Manchester Business Park, Aviator Way

Manchester City Council Comments – Applicant Response

Technical Note

Document Reference: 21347101-WAT-XX-XX-TN-N-800001_P01.01

10.0 PROBLEM LOCATION PLAN

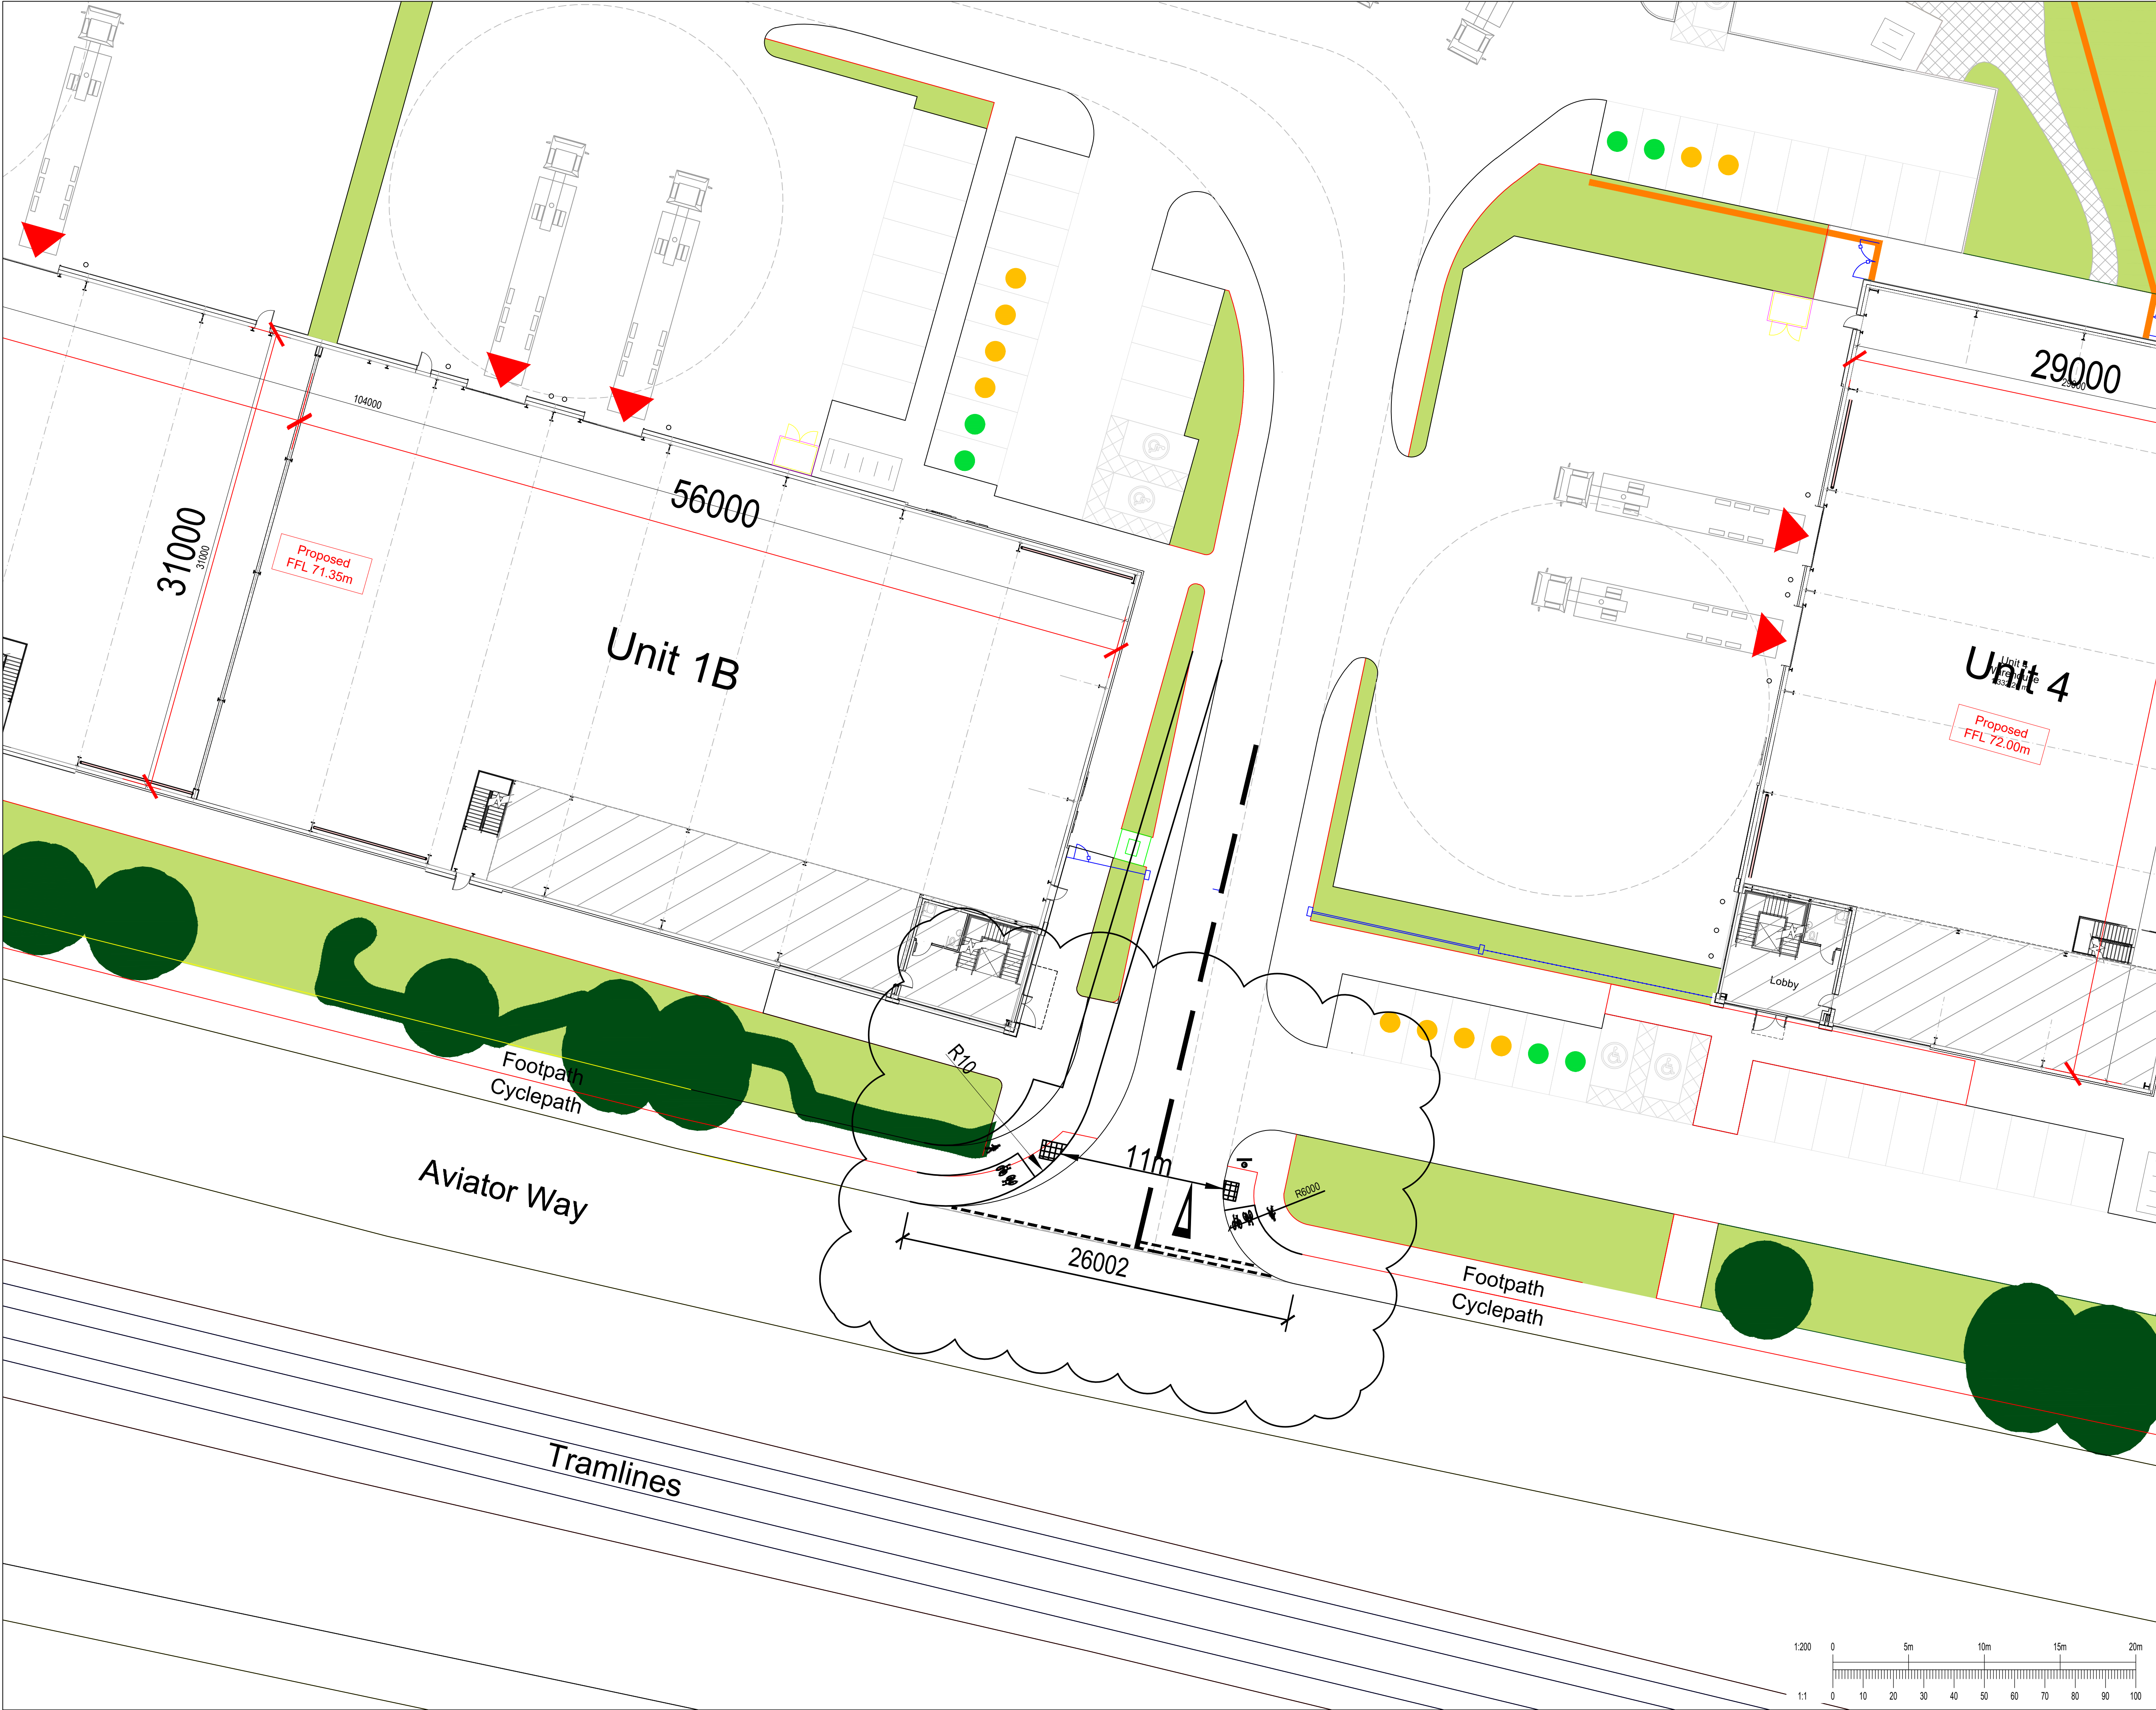
Location: Proposed site access on Aviator Way

Summary: **Risk of pedestrians and cyclists crossing access not being seen by approaching drivers**

Dwg. 050116 shows an indicative position for the crossing that is proposed to carry the existing segregated footway/cycleway across the proposed site access. This crossing position is set some way back from the eastbound channel of Aviator Way, appearing to propose a 'jug handle' crossing arrangement, in accordance with the recommendations of LTN 1/20 to cross the access away from the access radii, thus at the shortest route over the access. There are numerous semi-mature trees, surrounded by substantial low-level planting, to the northern verge of Aviator Way. Drawing no. 05010 shows removal of existing arboreal growth immediately adjacent to the access, but with the existing trees and shrubs to the west of the access to remain. There is a risk that drivers of eastbound vehicles, intending to turn into the site, will not see pedestrians or cyclists crossing the access from west to east.

It is recommended that sight lines for approaching drivers, to the position of the pedestrian/cycleway crossing are assessed, and further tree and shrub removal proposed as appropriate.

SITE ACCESS LAYOUT

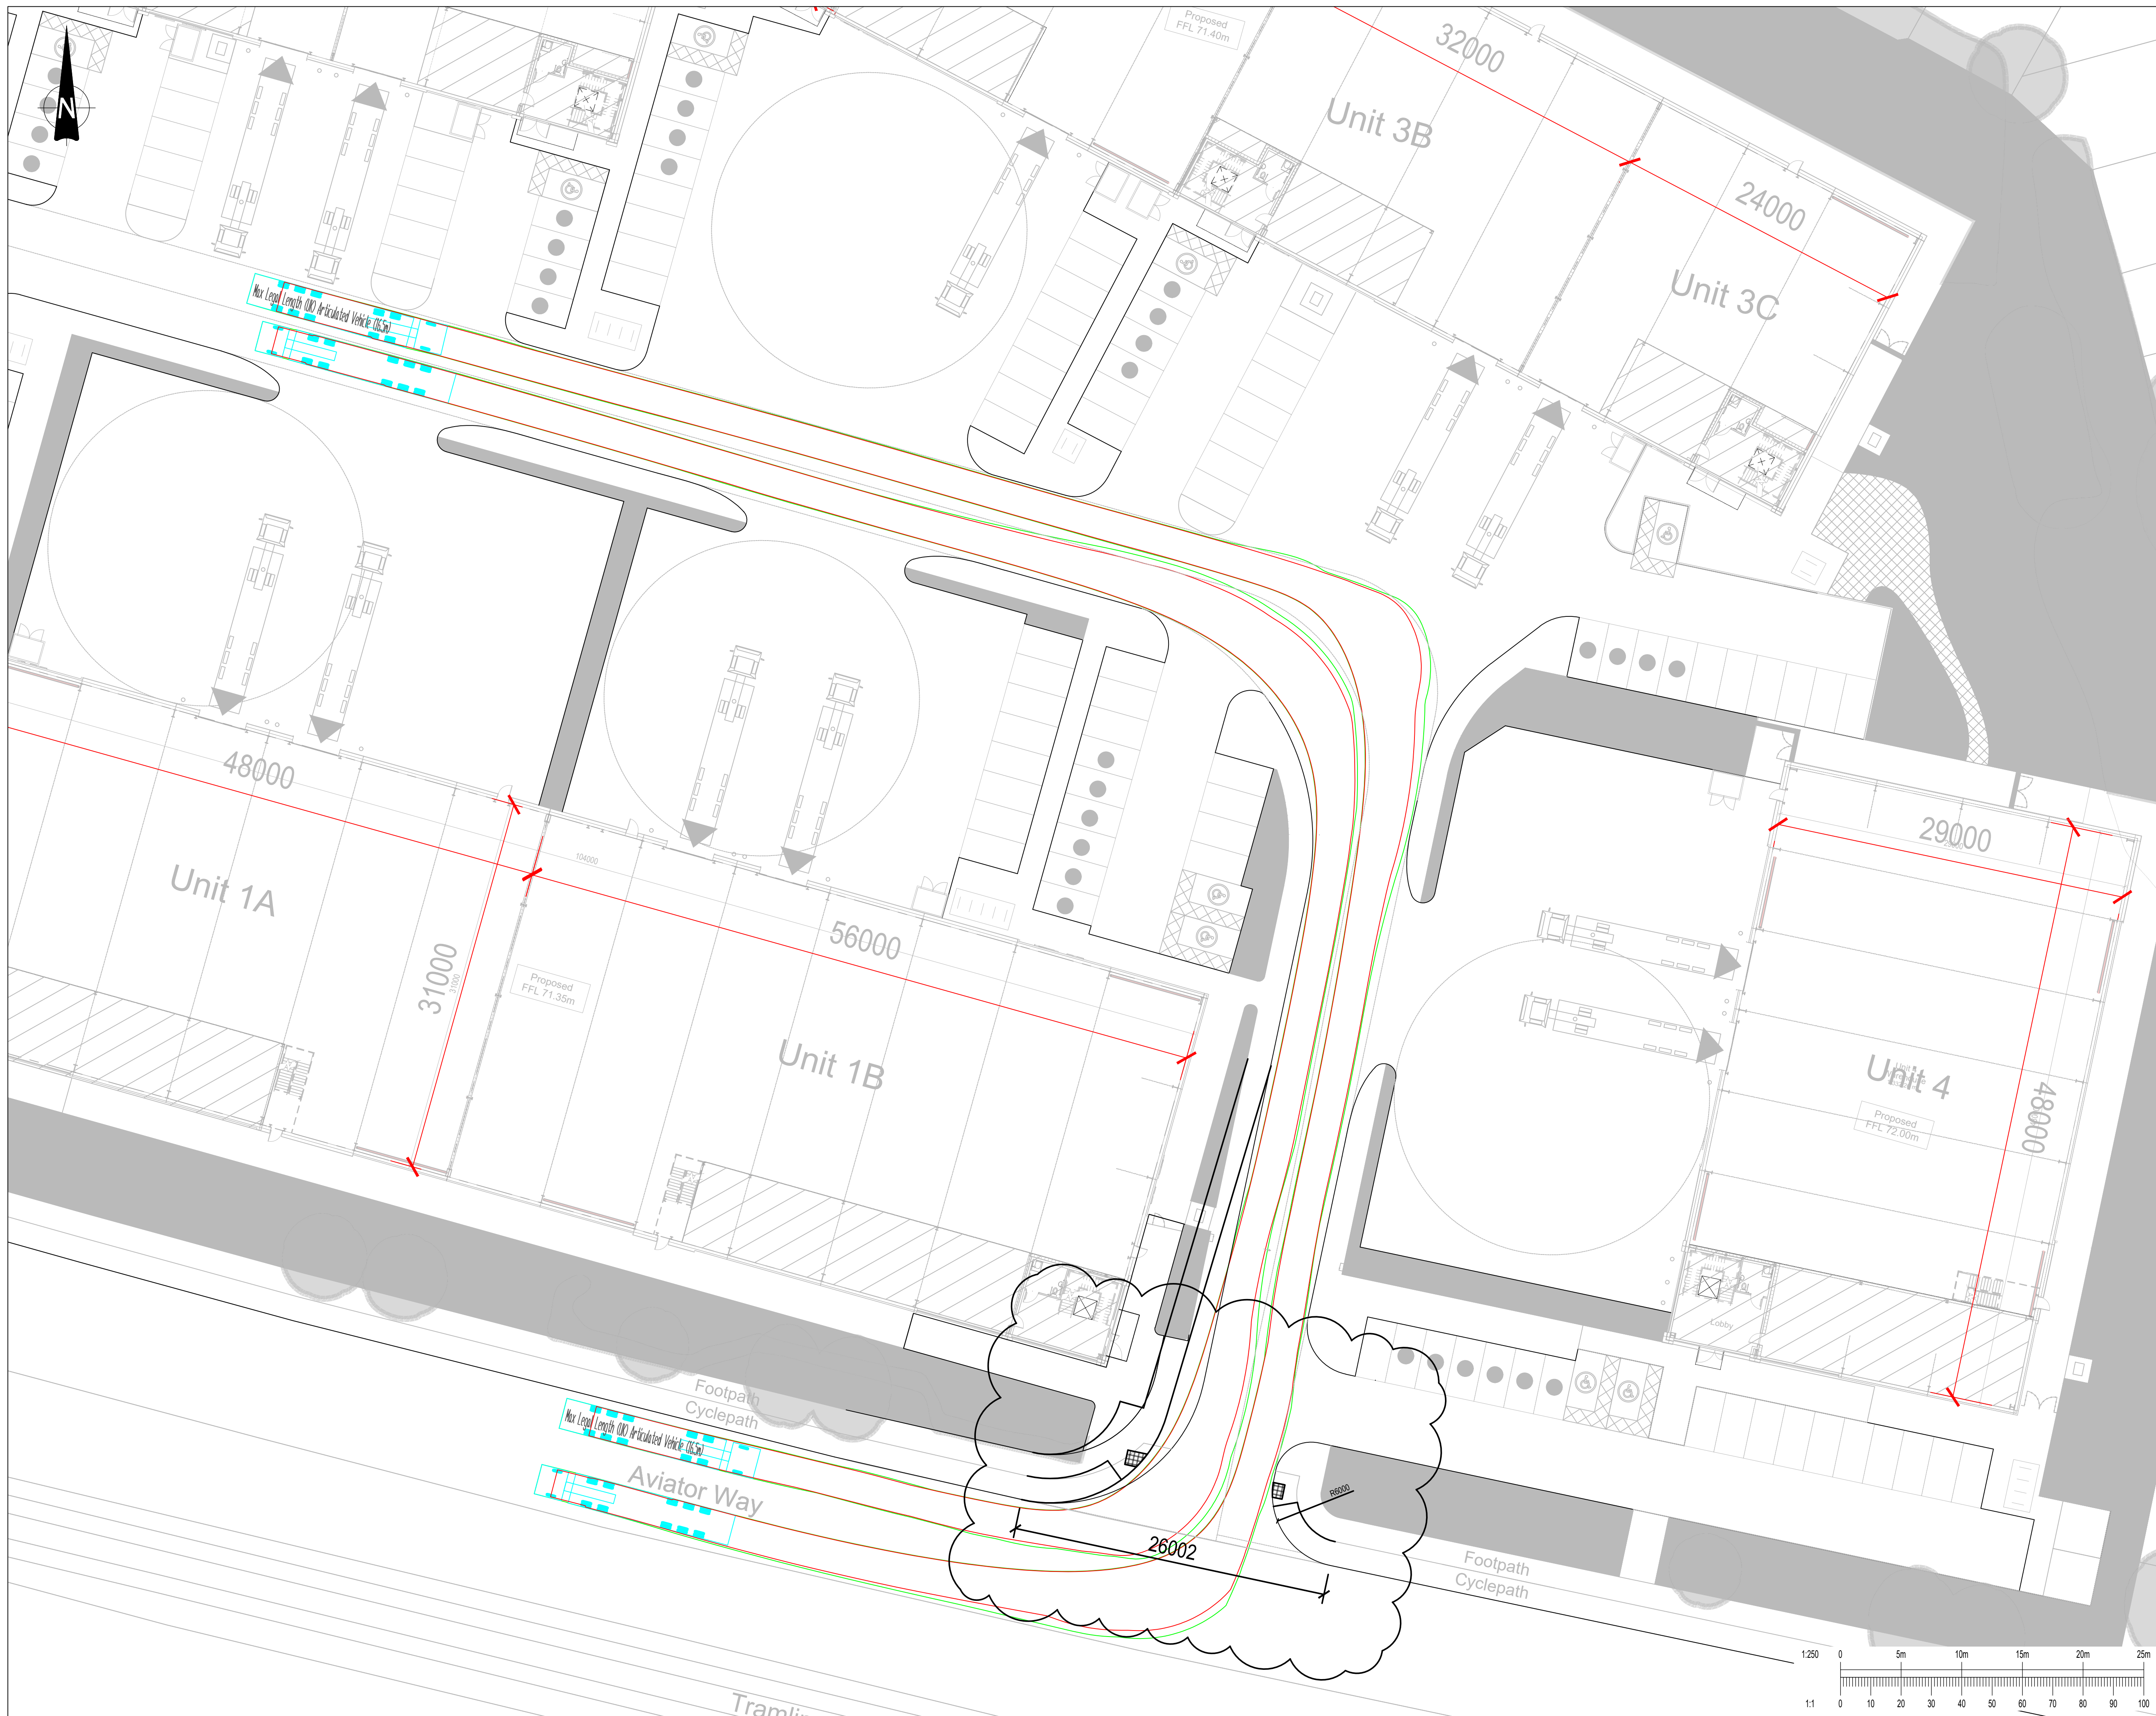
Confirmation is required on the width of the access point. Highways note that best practice is to provide a pedestrian refuge for access wider than 10.0m. Dropped kerb and tactile paving is required at the proposed site access.

o Access to the site is to be provided from Aviator Way via a new access junction.
o *A Road Safety Audit Stage 1 is required prior to determination.
o *Confirmation is required on the width of the access point. Highways note that best practice is to provide a pedestrian refuge for access wider than 10.0m.
o A 2.4m x 33m visibility splay assessment has been carried out at the site access - Acceptable in principle.
o *Dropped kerb and tactile paving is required at the proposed site access. Internal Access Road: o Proposed internal access road is to be 7.3m wide.
o *Swept path assessment for a 16.5m HGV demonstrates two-way movement at the proposed site access junction and along the internal service road. However, the current layout presents internal constraints with vehicle overrun clearly shown.

- 2.8. An indicative amended access arrangement is presented at [Appendix C](#). This amended access arrangement, which proposes amendments to the kerb radius and corner taper on entry to the Site, was discussed with MCC Highway officers on Monday 9 March 2026 and was positively received. A revised crossing point, 11.0m in width is proposed, with dropped kerbs and tactile paving provided. Discussion with MCC Highways officers indicated that this crossing width would likely be acceptable without the requirement for a pedestrian refuge, to maintain pedestrian desire line across the access junction.
